RNP U RWY 26 (AR) - Page 1
KARRATHA, WA (YPKA)

09 JUL 2026

PKAGN04-187

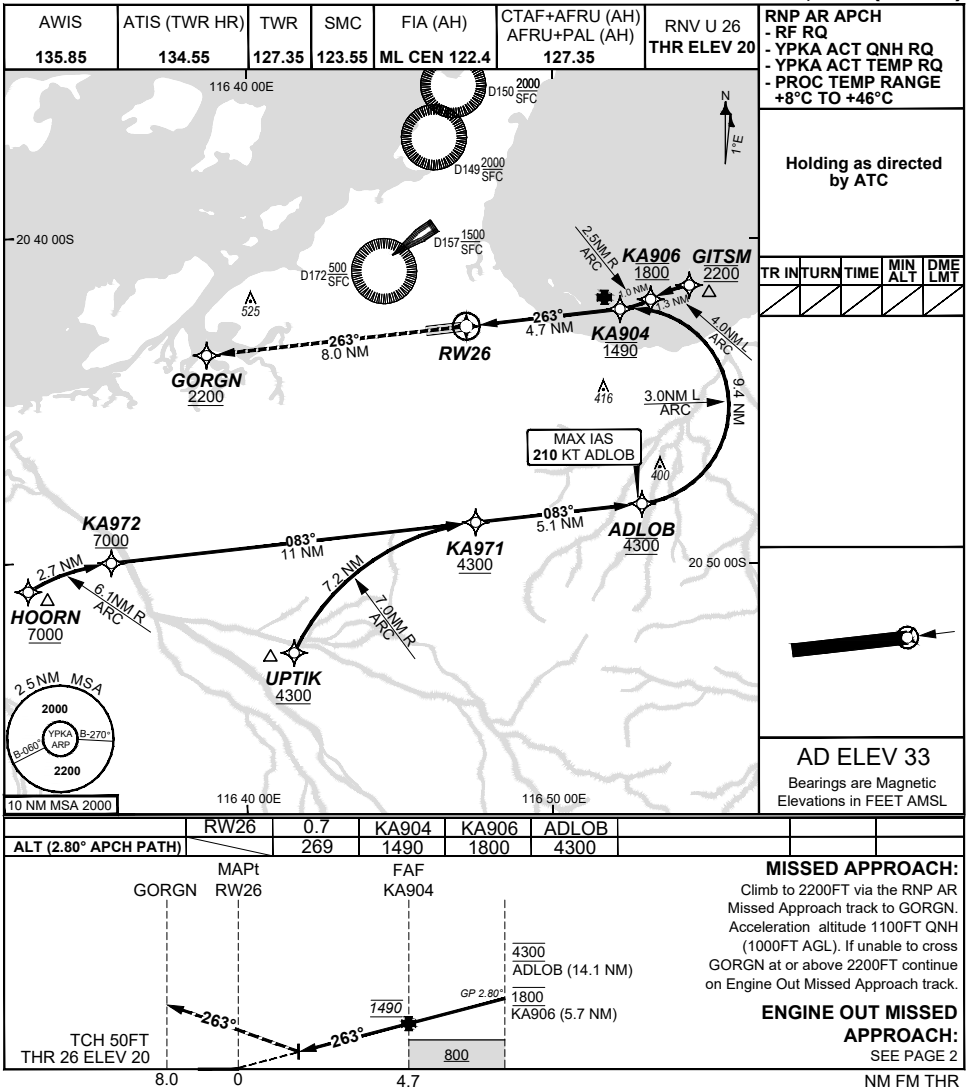
Changes: WATIR (H24) Freq changed to AWIS, change D154 to D157.
